INDIANA DEPARTMENT OF TRANSPORTATION

APPROVED MINUTES

April 16, 2026, Standards Committee Meeting

RE: Minutes from the April 16, 2026, Standards Committee Meeting

E 808-DLIM-03 Dotted Lines for Freeway Deceleration Lanes (shown markups)

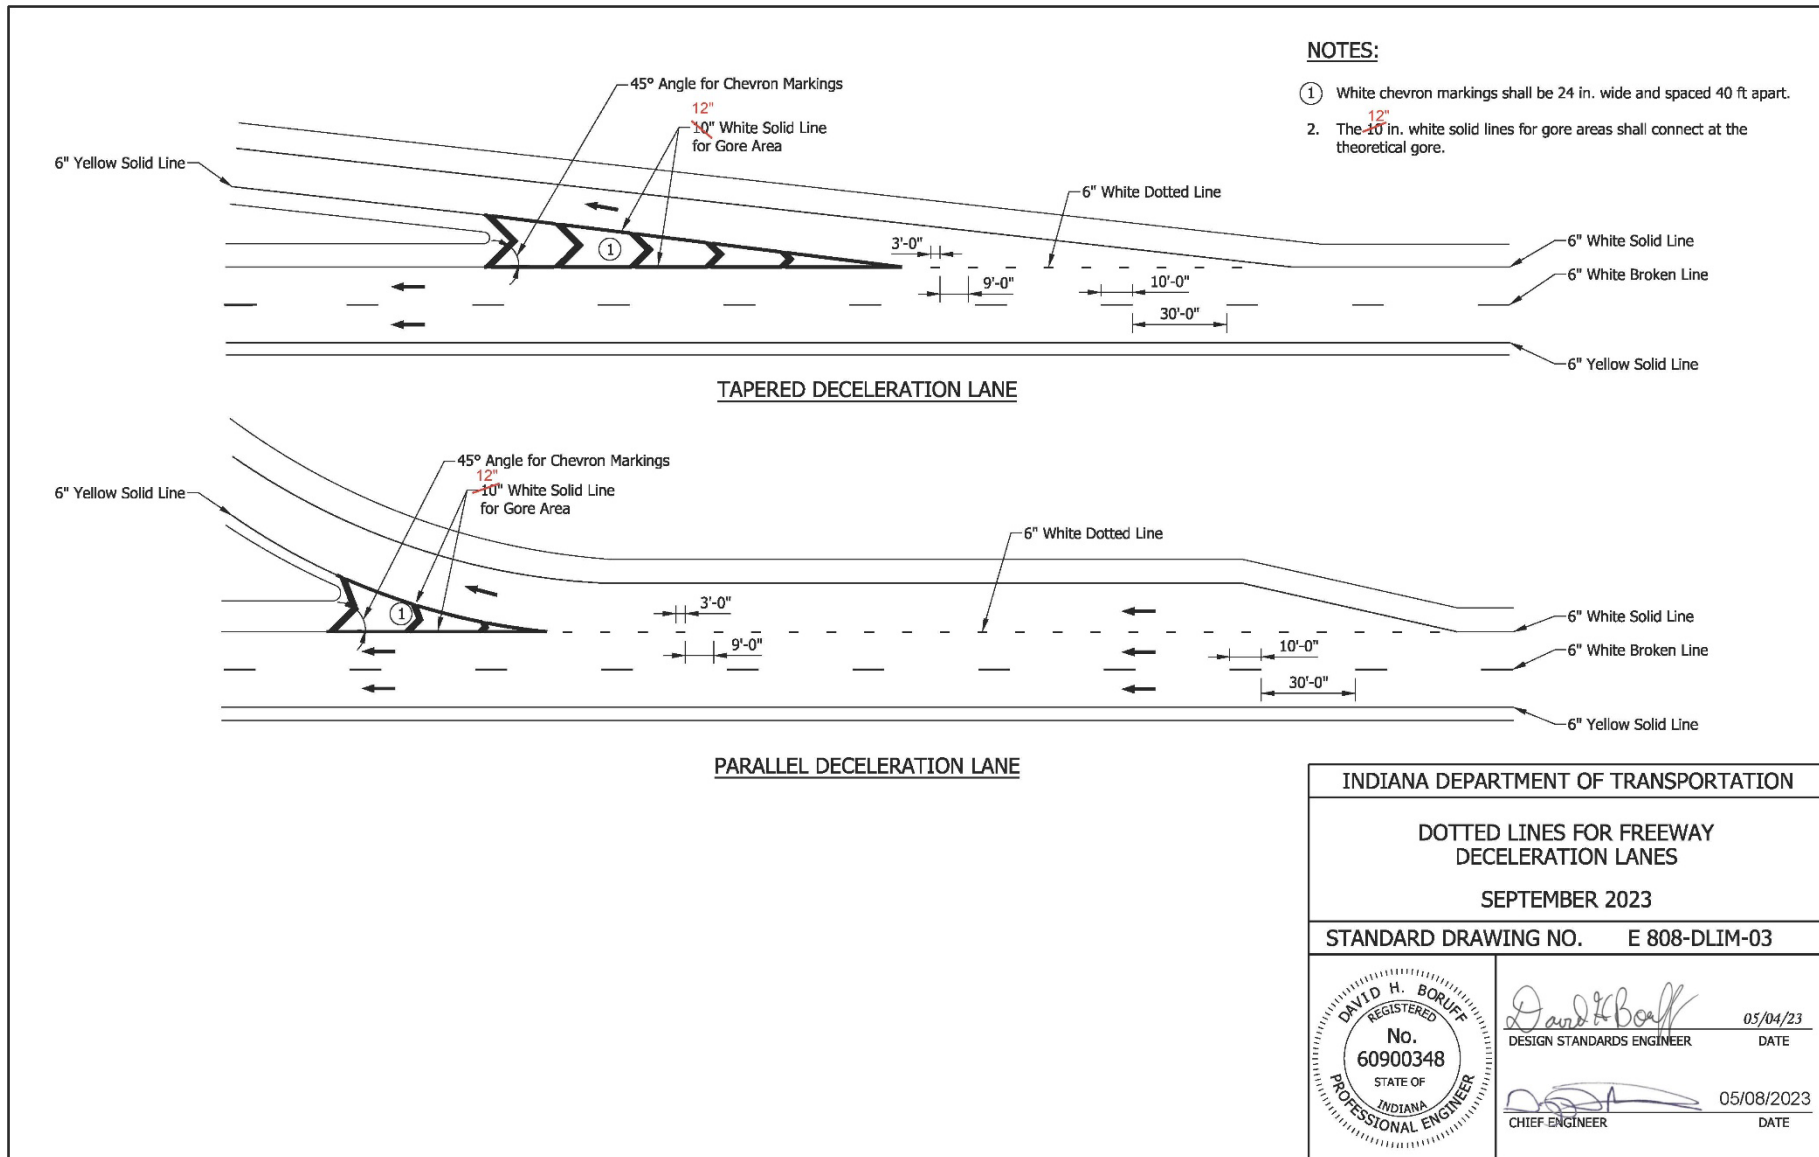
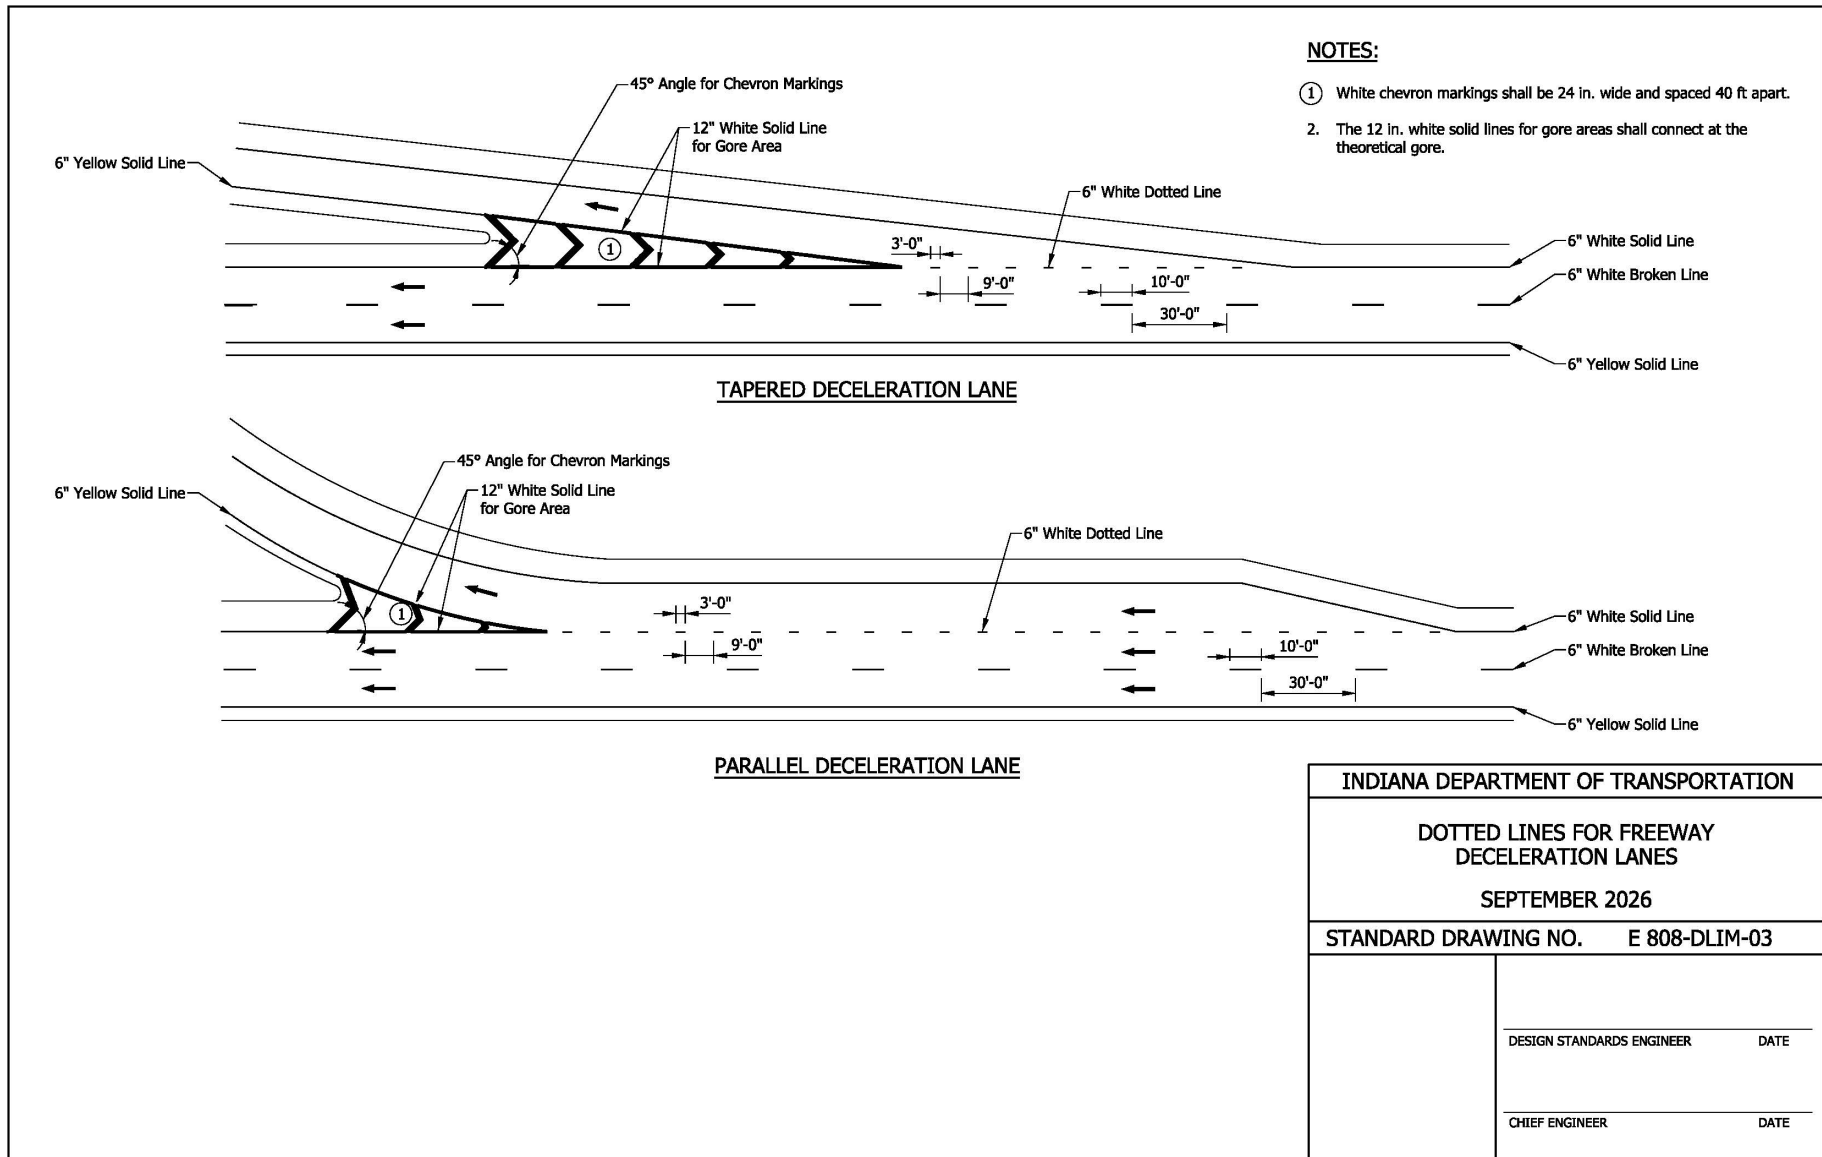
PROBLEM(S) ENCOUNTERED: Section 1B.02 of the 11th edition of the MUTCD requires states to update standard drawings to be in substantial conformance with the MUTCD. The 808-DLIM Standard Drawing series need various minor updates for the current edition of the MUTCD and the table in Standard Drawing 808-MKPM-06 needs to be updated for the current edition of the MUTCD.

REVISION TO STANDARD SPECIFICATIONS AND STANDARD DRAWINGS
E 808-MKPM-06 Transverse Markings Railroad Crossings (proposed draft)

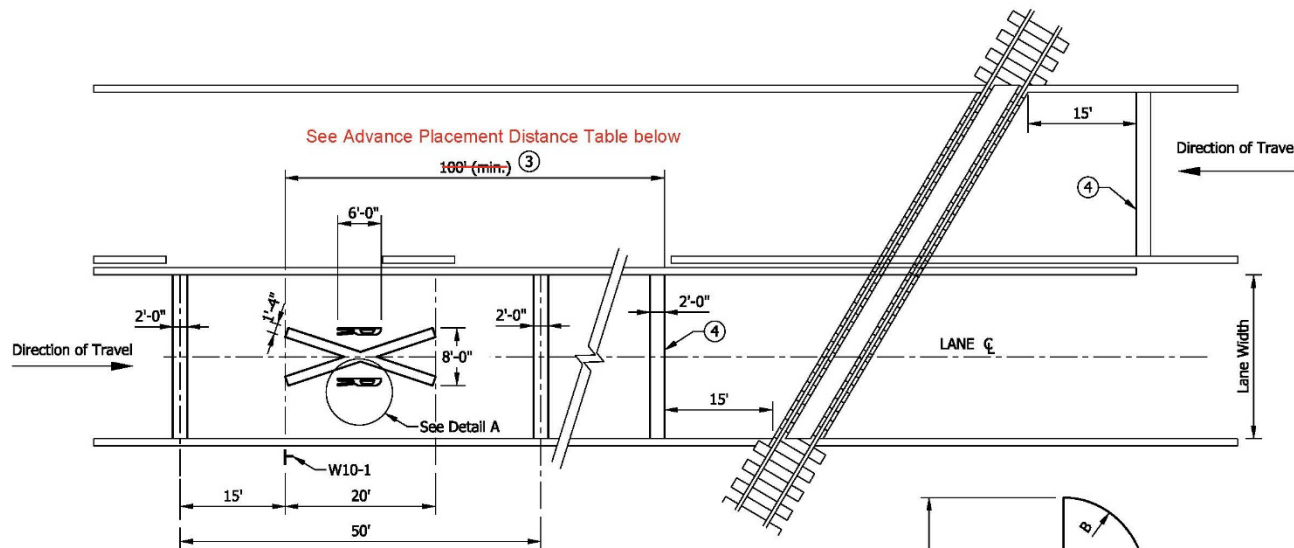
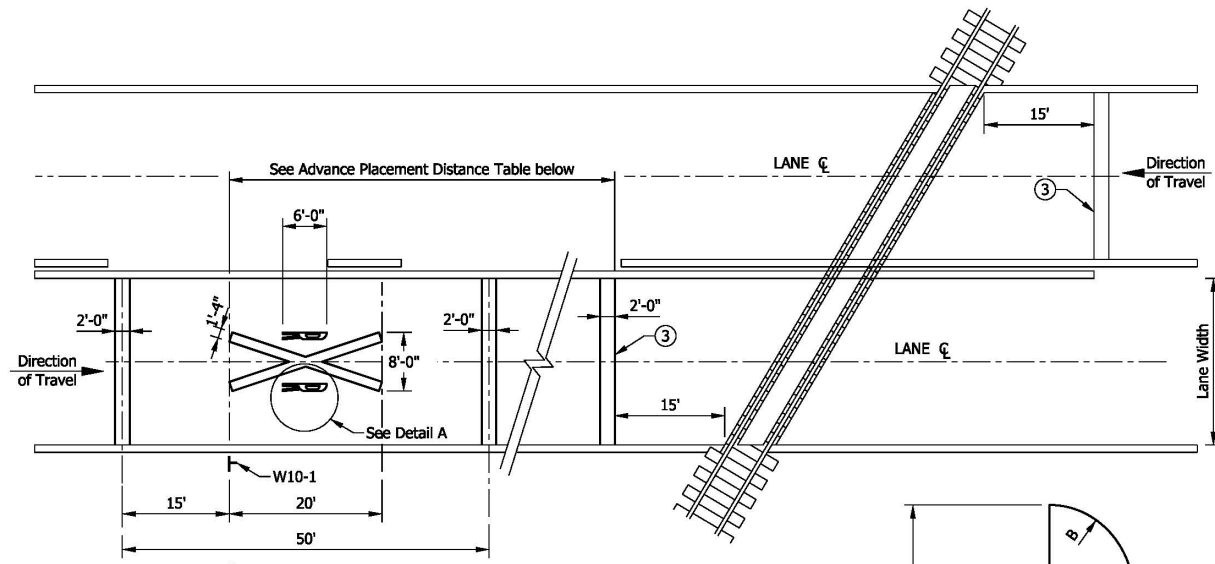
Mr. Koch stated that it seems Note #3 on sheet E 808-MKPM-06 could be problematic. I believe the Advanced Placement Table was created by INDOT based on the MUTCD. Yet changes could happen that go unnoticed. Should we remain silent and strike note #3 as we do not otherwise note each drawing with 'in accordance with the MUTCD'? Mr. Koch clarified that he is an engineer, not a lawyer.
